Hi-Fi Products
Service Bulletin

Model: TC-K950ES

No. 216

Subject: Level of High Frequency Content Decreases

SCHEMATIC DIAGRAM - AUDIO SECTION -

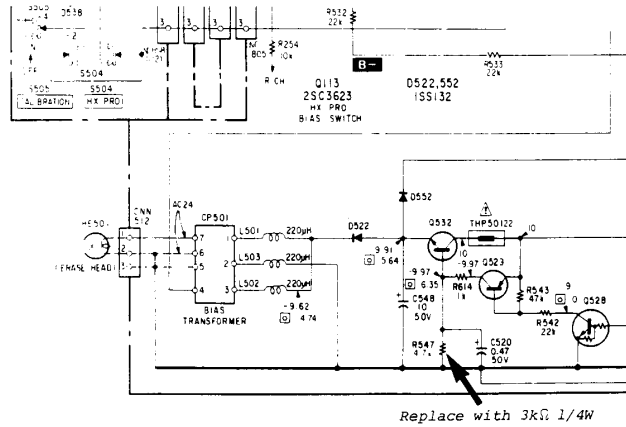
Symptom:
(153) When recording the B side after recording the A side of a cassette, the level of the A side high frequency content decreases. This problem is caused by excessive erase current.

Solution: Decrease the erase head current by changing R547 as described.

REF. NO.	FORMER		NEW	
	DESCRIPTION	PART NO.	DESCRIPTION	PART NO.
R547	1/4W RESISTOR 4.7K	1-249-425-11	1/4W RESISTOR 3K	1-247-842-11
